(Amended by Staff)
CITY PLANNING COMMISSION

- APPLICATION:**
- A. Negative Declaration
 - B. Special Permit to allow the construction of a 16,992, sq. ft. warehouse/office building in the Light Industrial/Planned Unit Development (M-1)(S)-PUD zone and Norwood Tech PUD.
 - C. Variance to allow for off-site parking and maneuvering on adjacent parcel.

LOCATION: Northeast corner of Research Drive and Opportunity Street

APPLC. NO. P87-455 **MEETING DATE** December 3, 1987 **ITEM NO.** 20

EXHIBIT A SITE PLAN

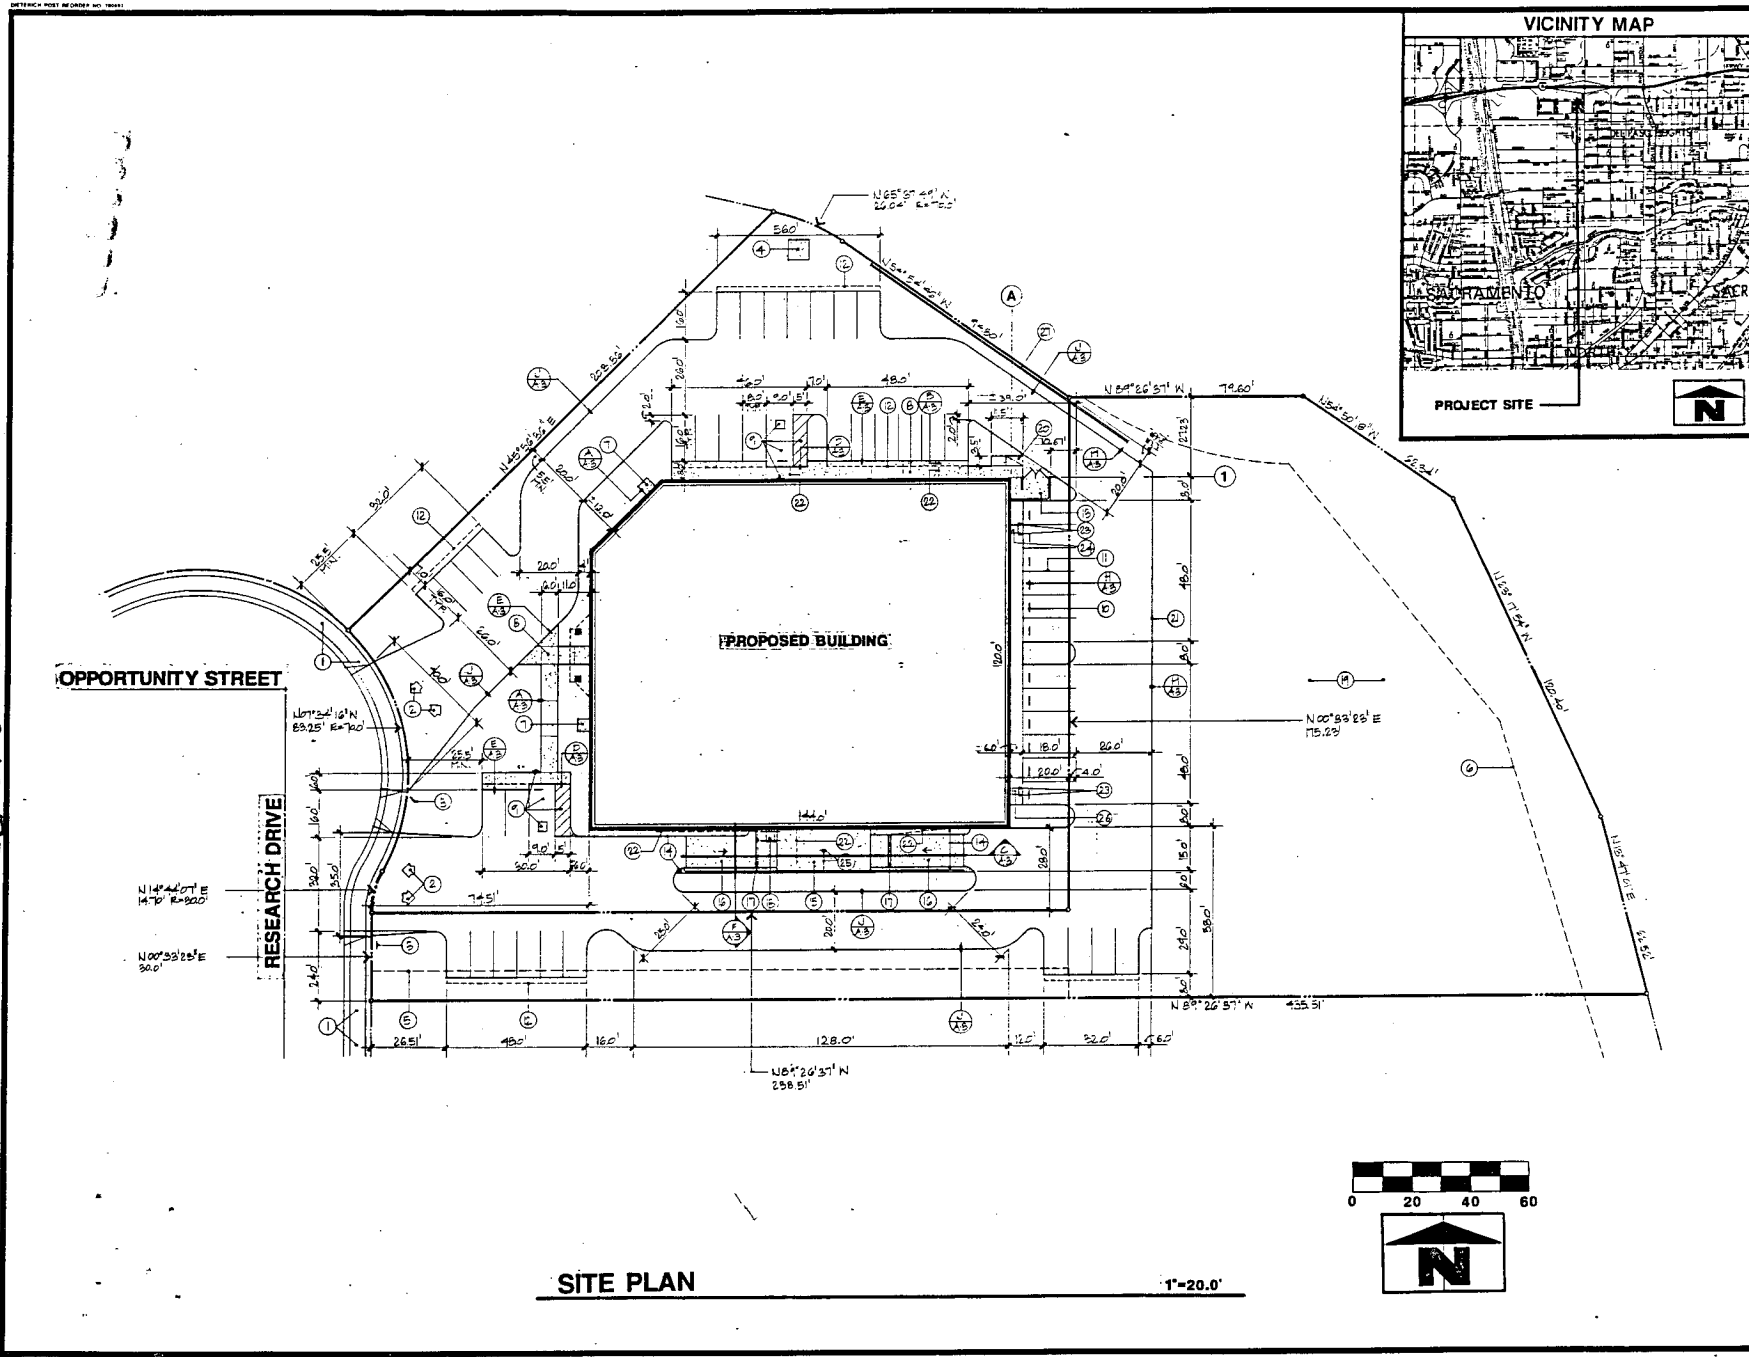
1. Landscaping: The submitted landscape plan indicates a 25.5 ft. front landscaped setback consisting of an undulating berm with turf and evergreen trees. Along the north property line, which is adjacent to the I-80 freeway off-ramp, a five foot planter is proposed. This planter will consist of ground cover and coastal redwoods planter at 25 ft. intervals along the entire northern perimeter. The southern property line is proposed to have an eight foot planter with ground cover and white alder trees at 25 foot intervals. A five foot planter with ground cover and trees is also proposed for the area just to the south of the loading dock area on the south side of the building. No landscaping is indicated on the landscaping plans for the east property line. Along this eastern side, the parking encroaches onto the adjacent parcel. Sod is proposed for a four foot planter between the parking area and the building. The undeveloped area to the east of the subject site should be maintained in a weed free condition.

Parking requirement for offices are calculated on the basis of one space per 300 square feet of office area within the warehouse; for warehouses, two spaces for each three employees, but in no event less than one space for each 1,000 sq. ft. of gross floor area for the first 20,00 sq. ft. Based on the above, the parking required for this project is 27 spaces. The proposed site plan indicates a total of 47 parking spaces. However, ten of these spaces are off-site and twelve require off-site maneuvering space. The applicant is requesting a variance for the off-site parking and maneuvering and has indicated to staff that a reciprocal access easement including an agreement which allows parking has been obtained. Staff has no objections to the variance. The additional parking is beneficial and will encourage less parking of service vehicles along the street. Staff recommends the parking of any service vehicles be located along the east building elevation, so as to minimize the visual impacts from I-80.

1. Driveways are to close, combine access or remove one and redesign - 35 ft. maximum width;
2. Reciprocal access easements required with adjacent parcels.

1. Construct standard improvements consistent with existing improvements.
2. Parking stalls to be 18 feet in depth.
3. North driveway will be radial to the elbow.
4. Maximum driveway width is 35 feet.
5. Obtain an reciprocal access easement to include an agreement which allows for parking, or
6. Merge lots or adjust lot lines, or

7. Lot line cannot split driveways.

6. The driveways shall meet the requirements of the Traffic Engineering Division.
7. The applicant shall submit a reciprocal parking and access agreement to the Planning Director prior to approval of final inspection of the structures by the Building Division.

EXHIBIT B ELEVATIONS

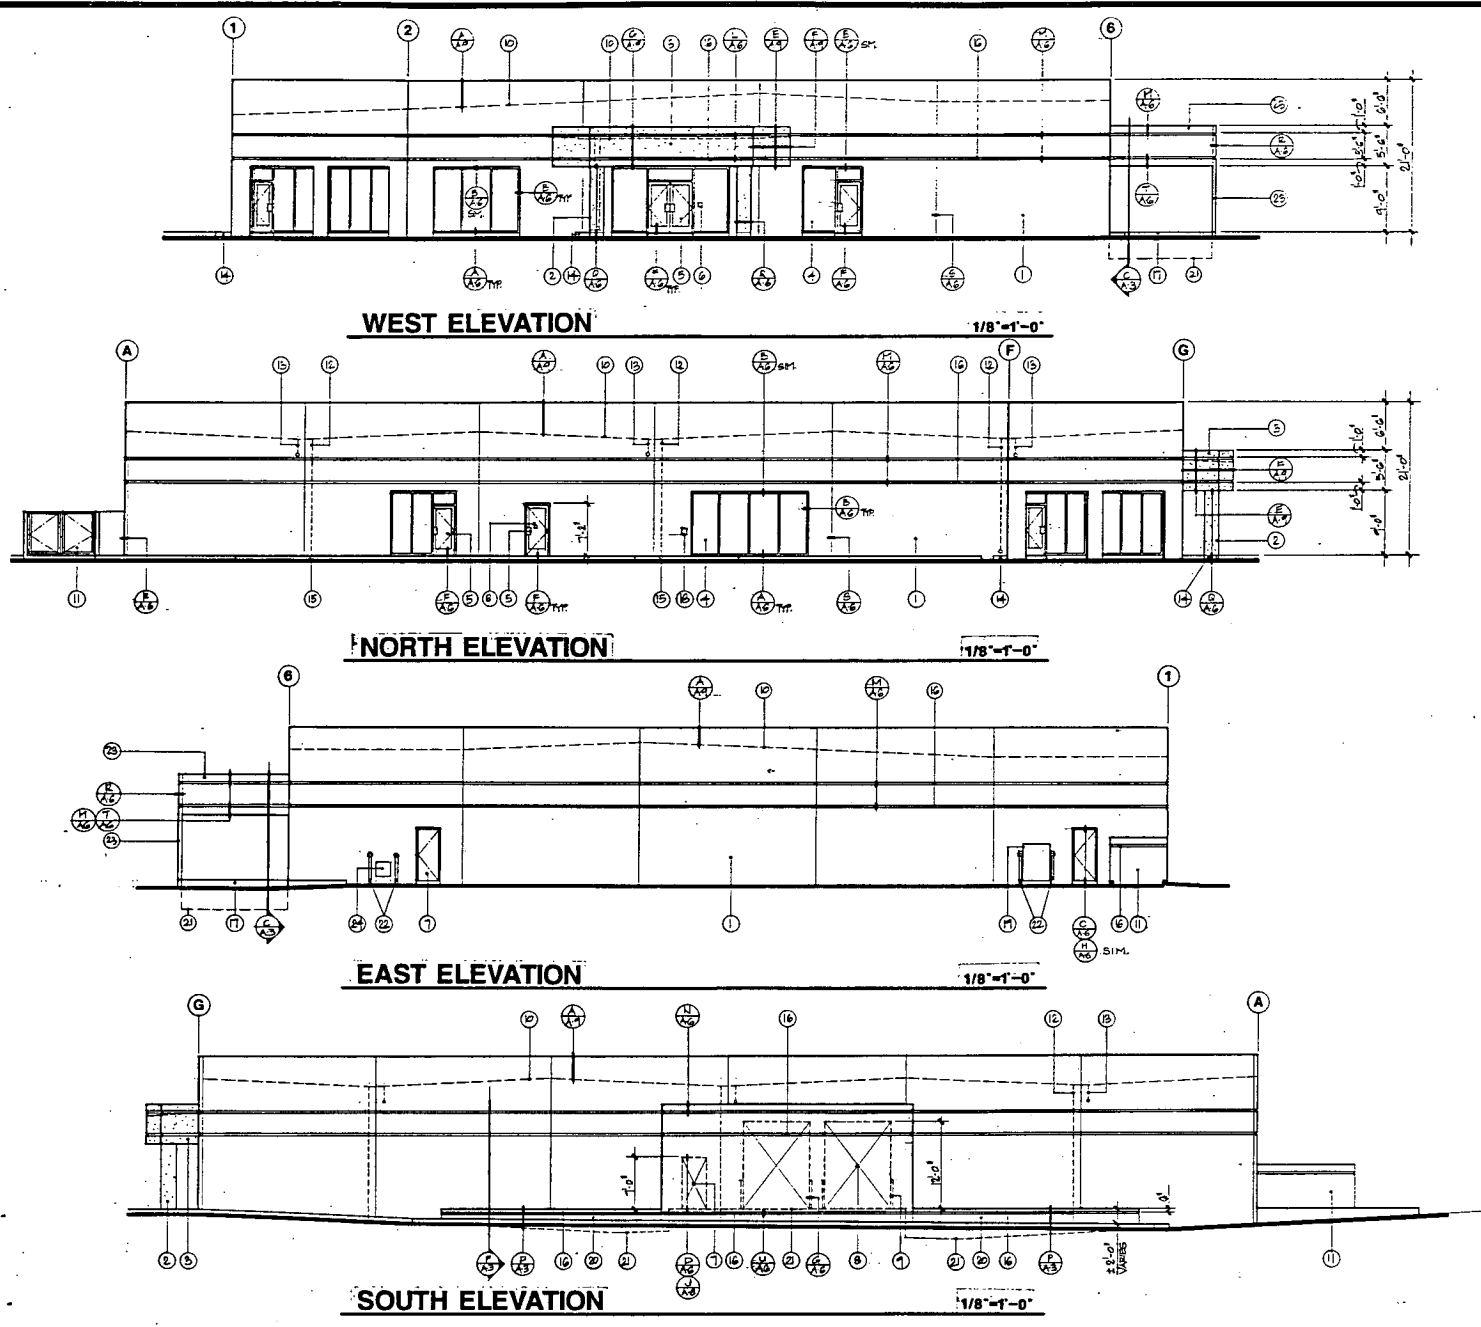
The applicant proposes a concrete tilt-up panel and cement plaster building exterior with contrasting color accent bands. Storefront windows are proposed for the west and north elevations. Loading docks with metal roll-up doors are proposed for the south side of the building with wing walls to screen the loading area. Cap sheet roofing is proposed that will be concealed by parapets.

The project, as designed, does not meet the objective of the PUD, "to preserve and enhance the aesthetic values throughout the project."

The Design Review staff has reviewed the proposed elevations and has recommended the following modifications:

- on the north, ~~east~~ and west elevations, ~~brick veneer should be~~ utilized as ~~the~~ exterior finish materials, ^{a combination of brick veneer and concrete design should be} This will greatly

There should be a majority of brick. The brick can be used in either a horizontal or vertical design. A formliner should separate the brick from the concrete. The south and east elevations should be painted a color compatible with the brick. The use of reveal lines and formliners is encouraged. recommended.

enhance the aesthetic quality of the building and will make the building more compatible with the adjacent buildings to the west and south.

- window openings should be recessed along the north and west elevations to break up the flat building surface visible from the roadways.

- the projecting wing walls on the south side of the building should be extended in ~~length~~ ^{Height} to further screen the visual impacts of the loading area.
- trash enclosure structure should meet the trash enclosure guidelines.

- a. a combination of brick veneer ~~(as specified)~~ and ^{concrete design} ~~concrete~~ shall be utilized on the north, east and west elevations; utilized on the north and west elevations ^(with a majority of brick); the south and east elevations shall be painted a color compatible with the brick, utilizing reveal lines and form liners; and.
- b. window openings shall be recessed along the north and west elevations and with the brick, utilizing reveal lines and form liners; and.
- c. the projecting wing walls on the south side of building screening the loading dock area shall be extended in ~~length~~ height.
